STERLING RANCH FILING NO.2

COVER SHEET

AS-BUILT PLANS
2026-05-26
EPC SF-20-15

**STRM_19 PROFILE
STA 0+00.00 TO 13+29.82
PUBLIC**

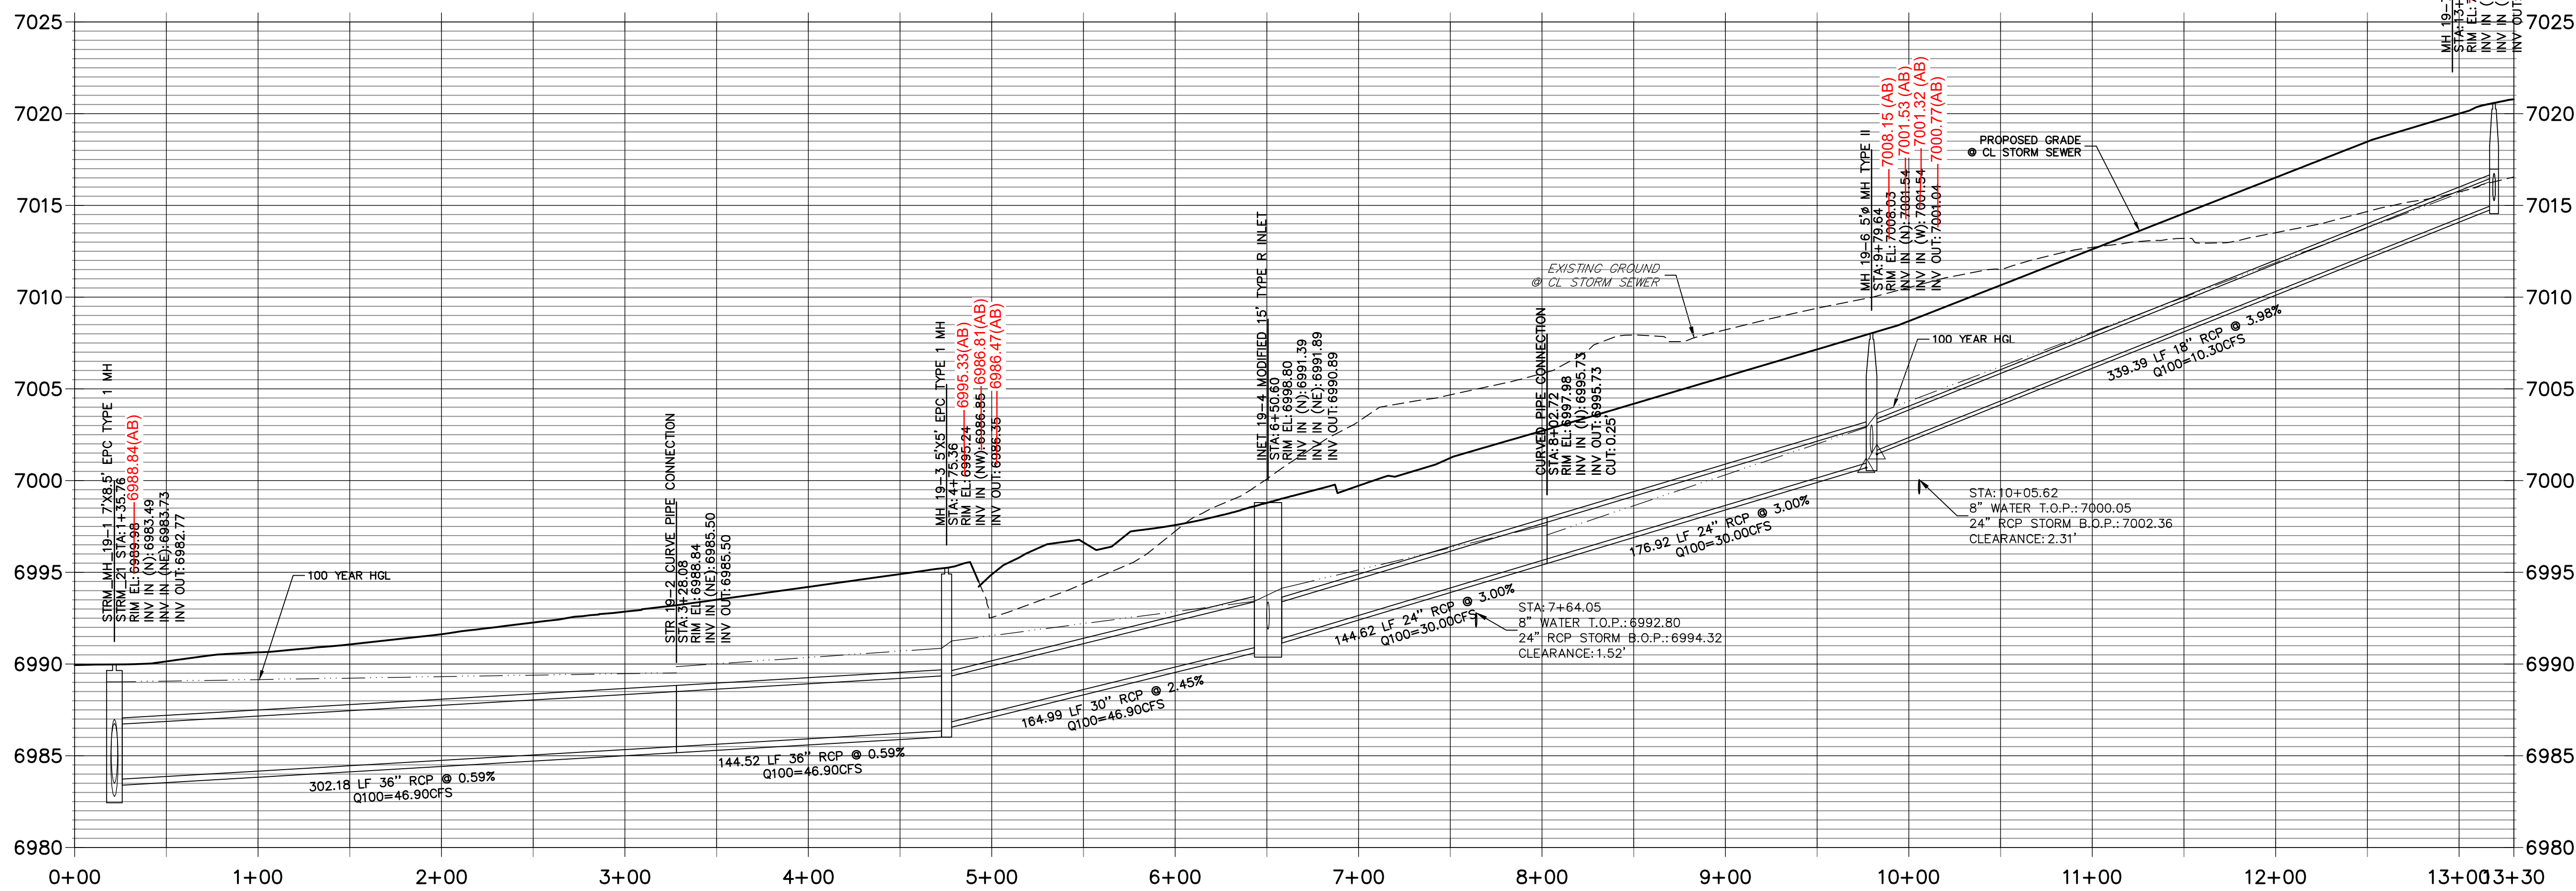
Overall quantities (public) as listed on certification letter are not matching with what is shown on CD's. If there is more of the system which is public, please revise on the CD's. Update quantities on certification letter as needed.

STORM 23 - 84" OUTFALL STILLING BASIN W/ HEADWALL & WINGWALL
SCALE: 1" = 4'

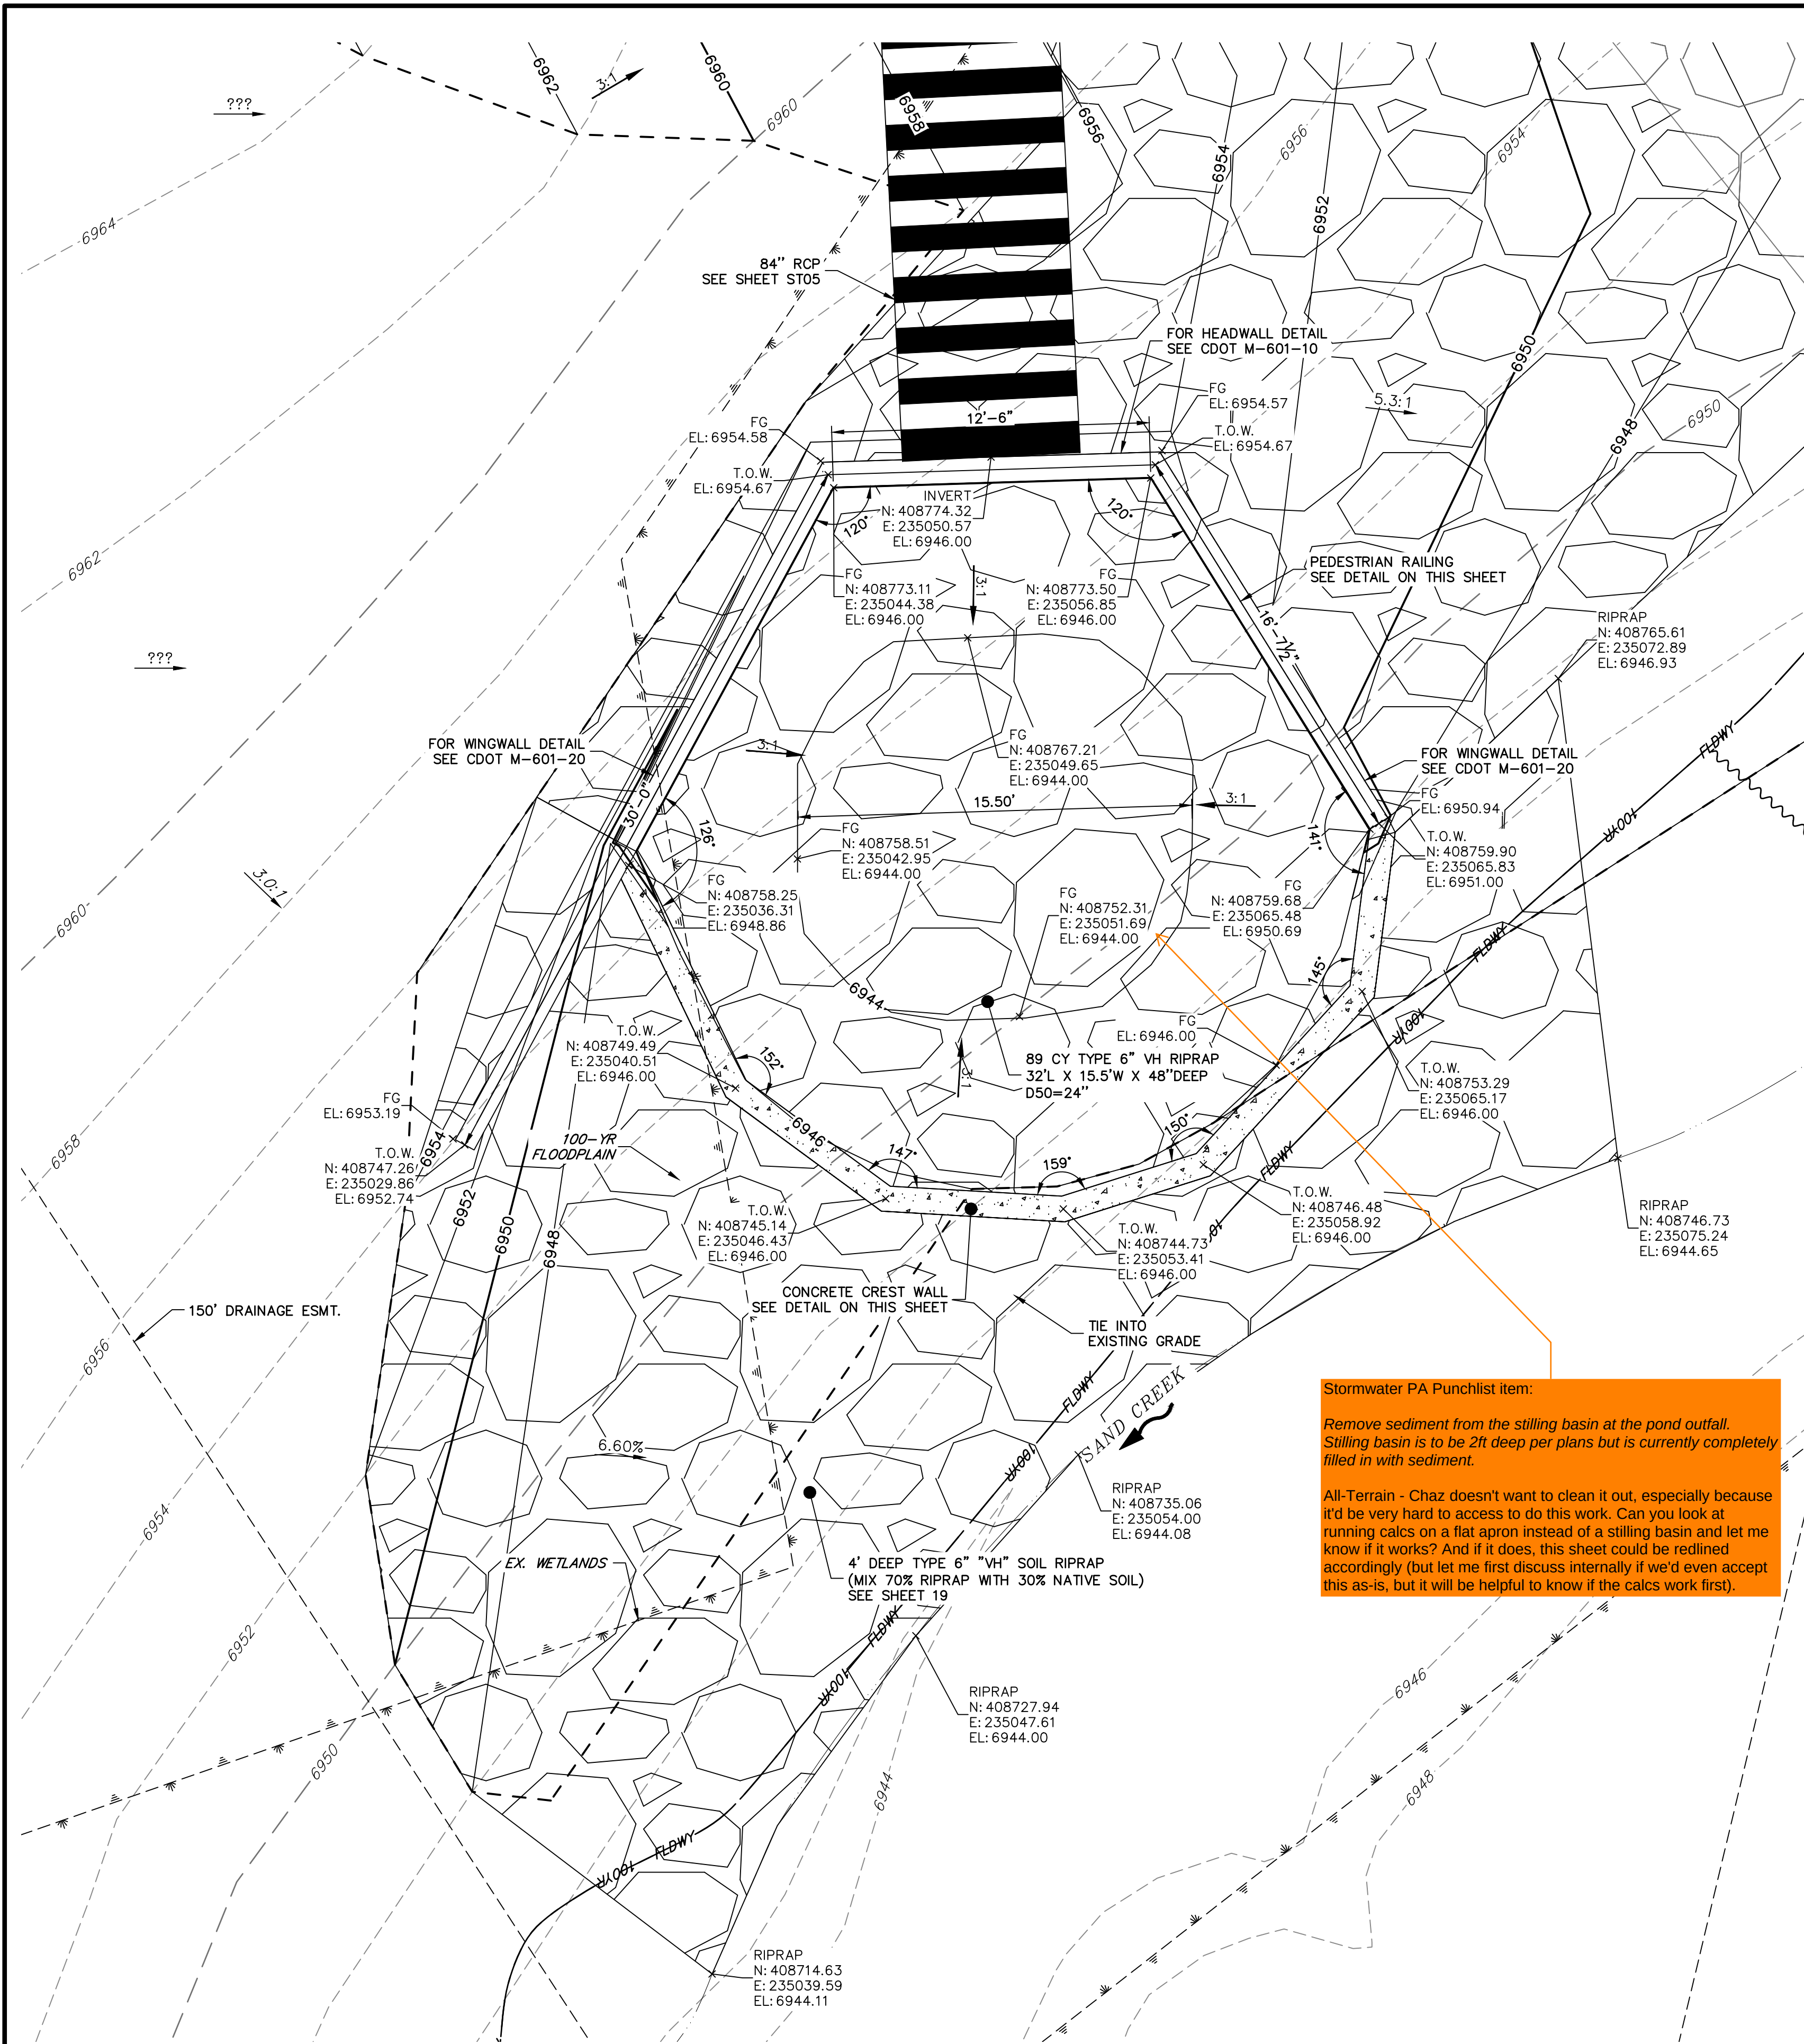
Stormwater PA Punchlist item:
Remove sediment from the stilling basin at the pond outfall.
Stilling basin is to be 2ft deep per plans but is currently completely filled in with sediment.
All-Terrain - Chaz doesn't want to clean it out, especially because it'd be very hard to access to do this work. Can you look at running calcs on a flat apron instead of a stilling basin and let me know if it works? And if it does, this sheet could be redlined accordingly (but let me first discuss internally if we'd even accept this as-is, but it will be helpful to know if the calcs work first).

POND W-4 FULL SPECTRUM DETENTION BASIN DATA

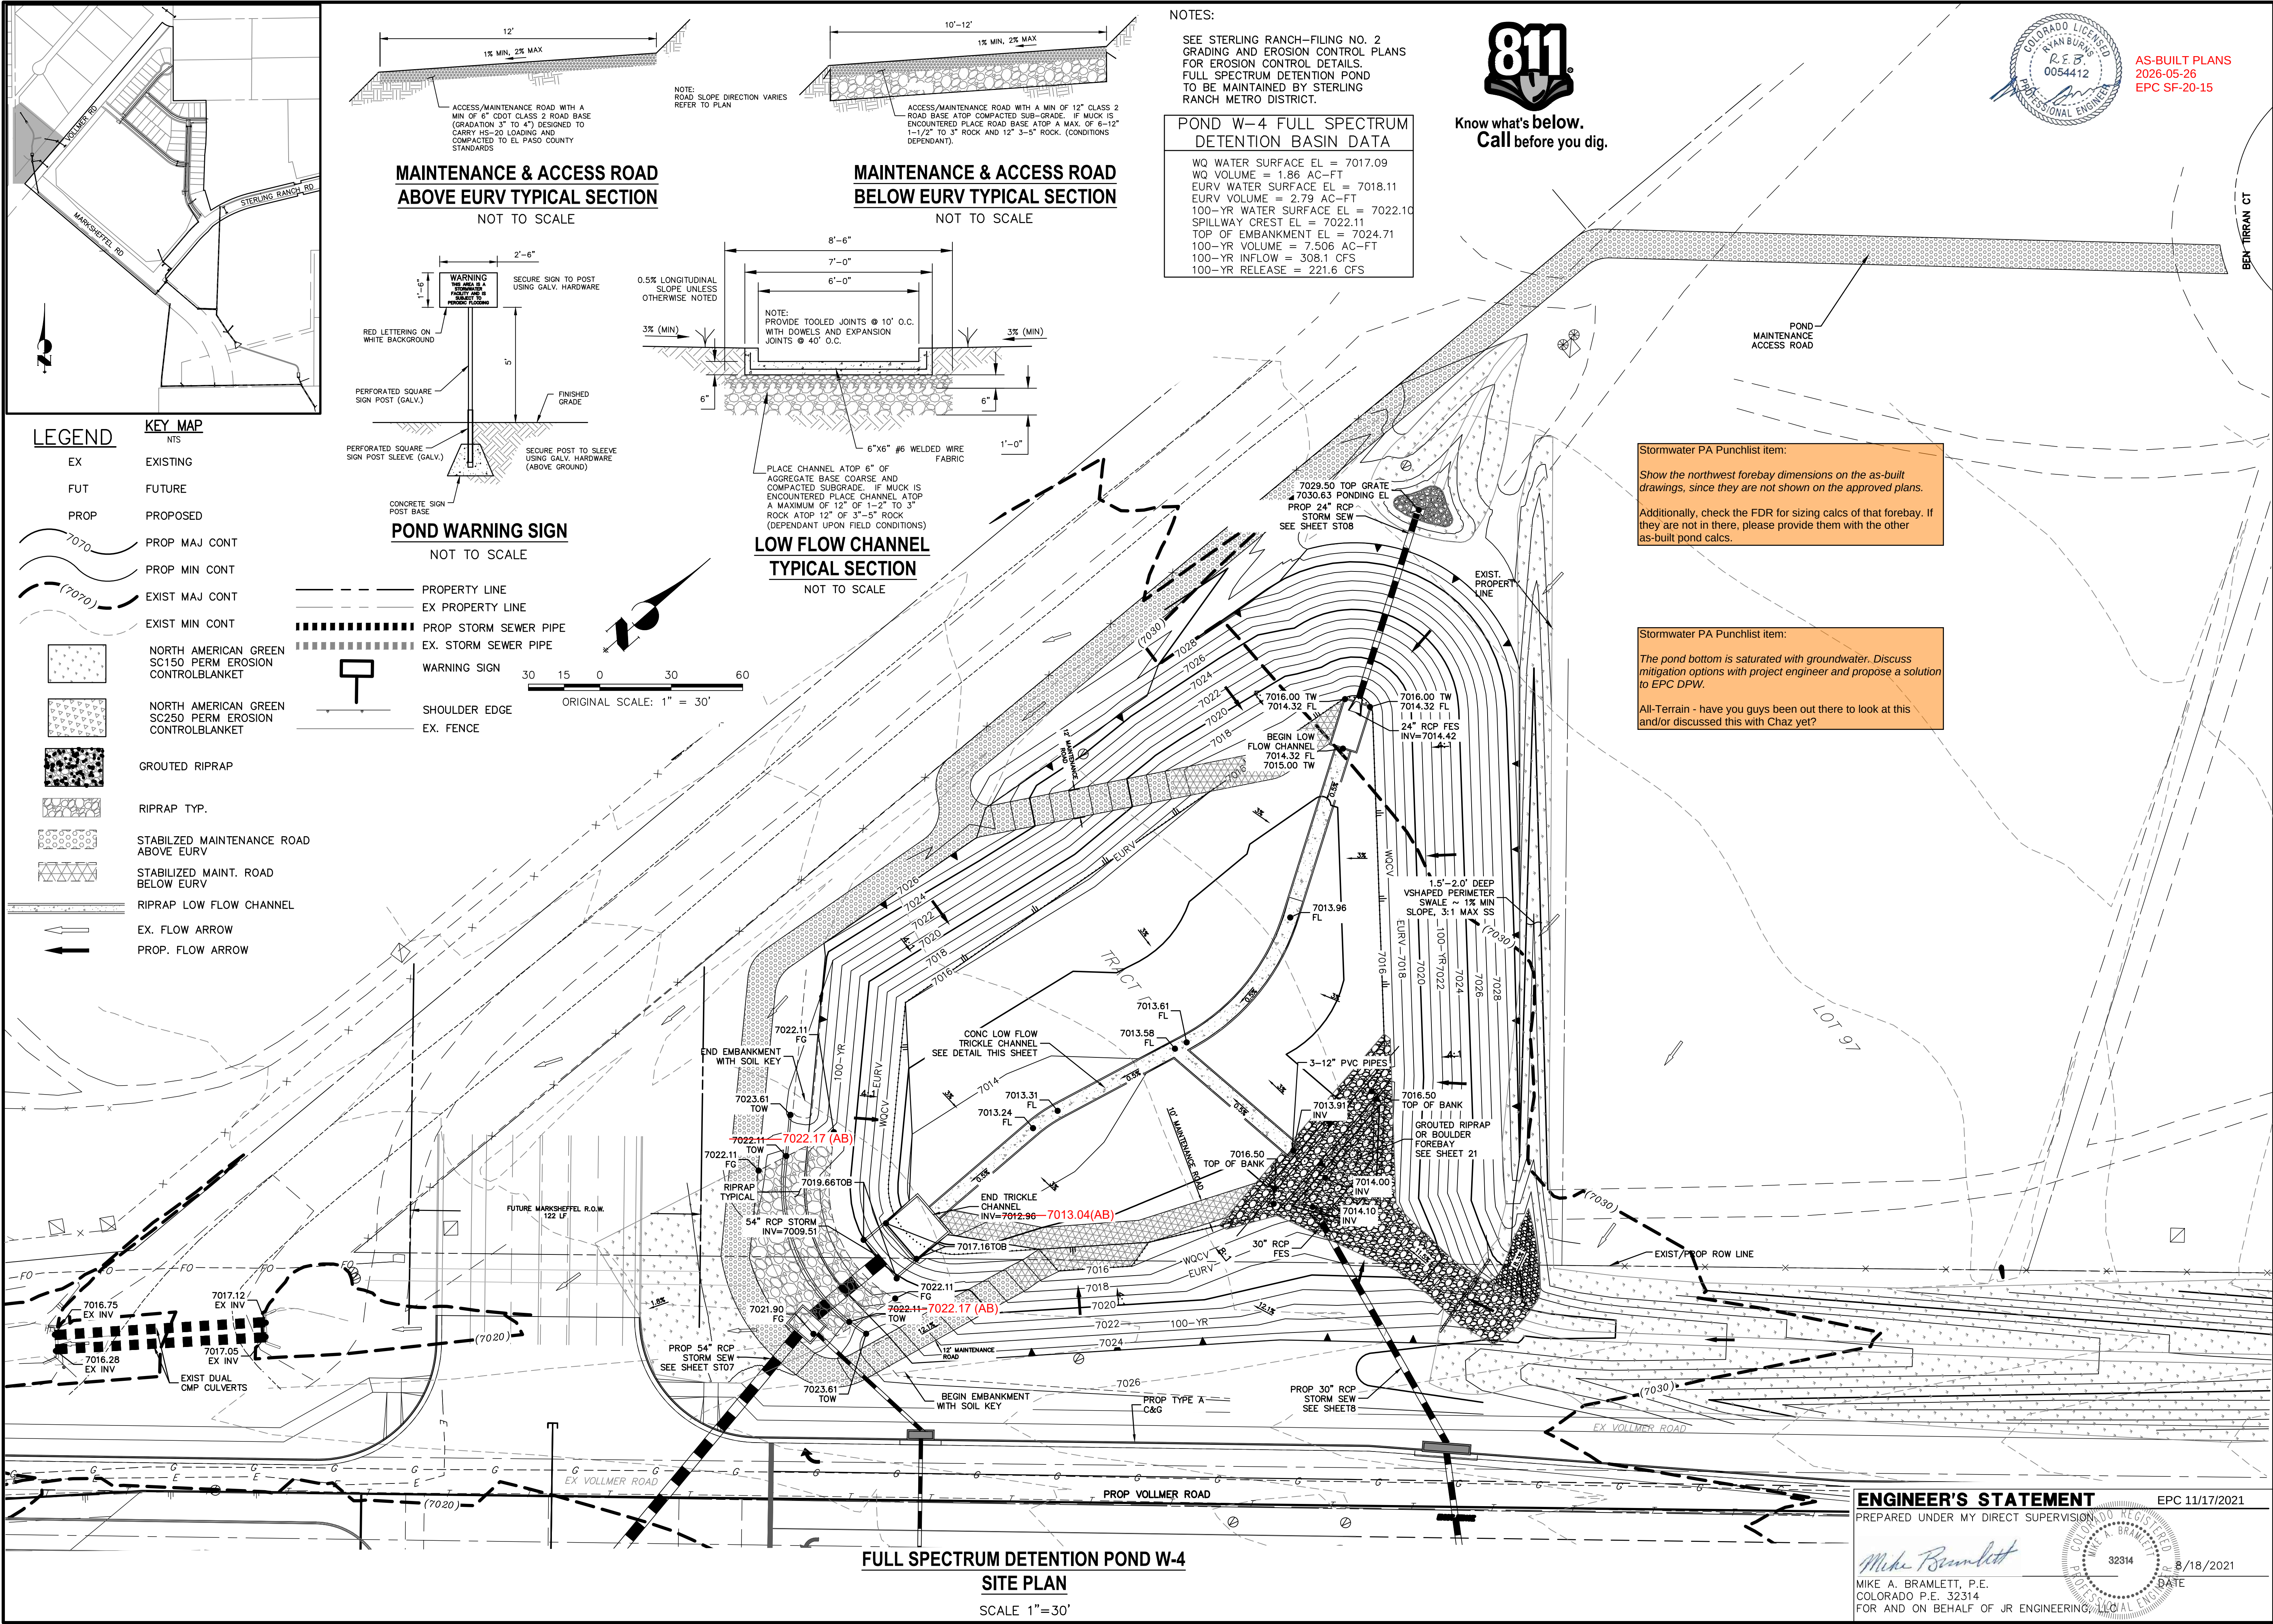
Stormwater PA Punchlist item:
Show the northwest forebay dimensions on the as-built drawings, since they are not shown on the approved plans.
Additionally, check the FDR for sizing calcs of that forebay. If they are not in there, please provide them with the other as-built pond calcs.

Stormwater PA Punchlist item:
The pond bottom is saturated with groundwater. Discuss mitigation options with project engineer and propose a solution to EPC DPW.
All-Terrain - have you guys been out there to look at this and/or discussed this with Chaz yet?
